Access Compliance Report

Public Rights-of-Way

(Curb Ramps)

Intersection ID: 10379	Main Street: ANDERSON_ST	Cross Street: E_SUGAR_CREEK_RD	Location: S
ADA ID: 6E1E8D64CFA5	Ramp Type: PerpDiag	Initial Pass/Fail: Fail	Overall Compliance: No
		Severity Score: 10

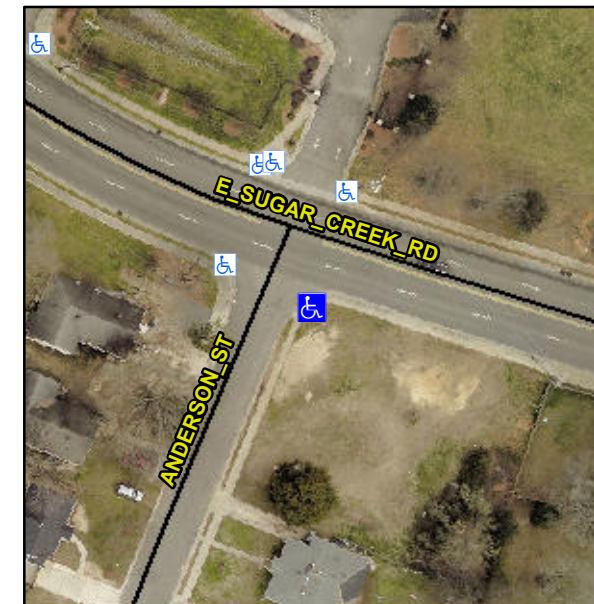
Not Found, R304.5.1, R304.5.3

Compliance	Description	Data	Compliance	Description	Data
N/A	Ramp Length (in)	58.0	Yes	Ramp Slope (%)	6.8
No	Ramp Width (in)	42.5	No	Ramp XSlope (%)	3.4
N/A	Flare Type LT	N/A	N/A	Flare Type RT	N/A
N/A	Flare Slope LT (%)	N/A	N/A	Flare Slope RT (%)	N/A
N/A	Flare Traversable LT?	N/A	N/A	Flare Traversable RT?	N/A
N/A	Landing Length (in)	N/A	N/A	DWS Provided?	N/A
N/A	Landing Width (in)	N/A	N/A	DWS Contrast?	N/A
N/A	Landing Slope (%)	N/A	N/A	DWS Length (in)	N/A
N/A	Landing X Slope (%)	N/A	N/A	DWS Full Width?	N/A
N/A	Landing Curb? (Y/N)	N/A	N/A	DWS Offset (in)	N/A
N/A	Shared Landing?	N/A			
N/A	Gutter Ponding?	N/A	N/A	Gutter Slope (%)	N/A
N/A	Gutter Lip Ht (in)	N/A	N/A	Gutter X Slope (%)	N/A
N/A	Painted X Walk1?	No	N/A	Painted X Walk2?	No
	X Walk 1 Direction	To NE		X Walk 2 Direction	To NW
N/A	X Walk 1 Width (in)	N/A	N/A	X Walk 2 Width (in)	N/A
	X Walk 1 Slope (%)	2.8		X Walk 2 Slope (%)	0.4
	X Walk 1 X Slope (%)	0.4		X Walk 2 X Slope (%)	3.4

Remove & Replace Curb Ramp With Two New Directional Ramps or Equivalent.
